Desktop 4th Generation Intel[®] Core[™] Processor Family, Desktop Intel[®] Pentium[®] Processor Family, and Desktop Intel[®] Celeron[®] Processor Family

Specification Update

March 2017 Revision 037US

Document Number: 328899-037US

Desktop 4th Generation Intel[®] Core[™] Processor Family Top-Side Markings Figure 1.

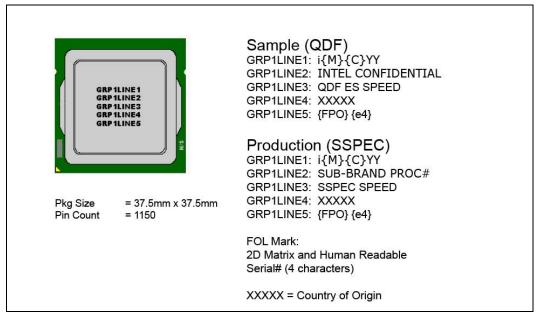
The processor stepping can be identified by the following component markings.
